River Bend Station - Unit 1
Docket No. 50-458

Please find enclosed the revised Requests for Relief RR0007, RR0010 and RR0012B to the River Bend Station (RBS) Inservice Inspection (ISI) Plan. These revisions correct typographical errors found during a review of all ISI Plan Requests for Relief, the ISI Plan and Safety valuation Reports for the RBS ISI Program, as discussed during the exit meeting for NRC Inspection 91-28 with your Messrs. I. Barnes, L. Gilbert and W. McNeill on November 22, 1991.

REQUEST FOR RELIEF: RR0012B

SKETCH NUMBER: 1

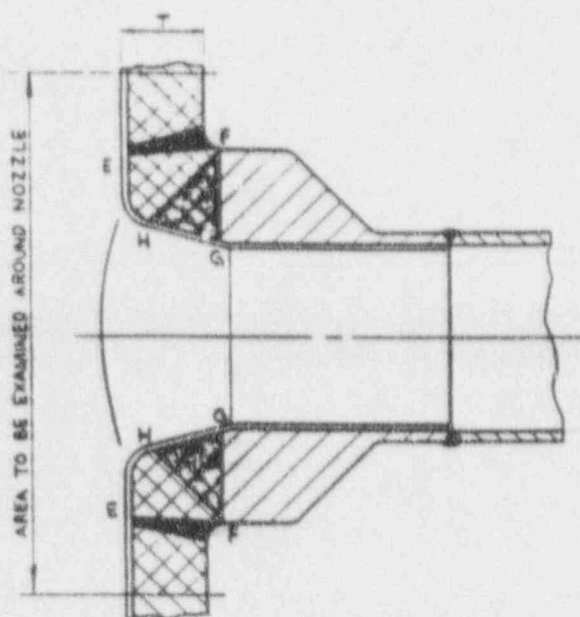
Due to the geometry of the nozzles, the ultrasonic examination from the outside surface is only possible from the vessel side of the nozzle-to-vessel welds.

1) The preservice ultrasonic examination of the nozzle-to-vessel welds listed above achieved full coverage for parallel and transverse reflectors from the vessel side of the welds. Approximately 50% of the required volume on the nozzle side of the weld was inspected for parallel reflectors from the vessel side of the welds. All of the weld metal examined. Shaded areas HFG in the attached sketch were not covered for parallel reflectors, and areas EFGH were not covered for transverse reflectors. (See attached Sketch 1).

- 2) The inservice Volumetric ultrasonic examination coverage for the listed nozzle-to-vessel welds will be the same as that obtained for the preservice inspection of the welds. Completion of the remaining portion of the required examination is impractical and would result in undue hardship without a compensating increase in safety.
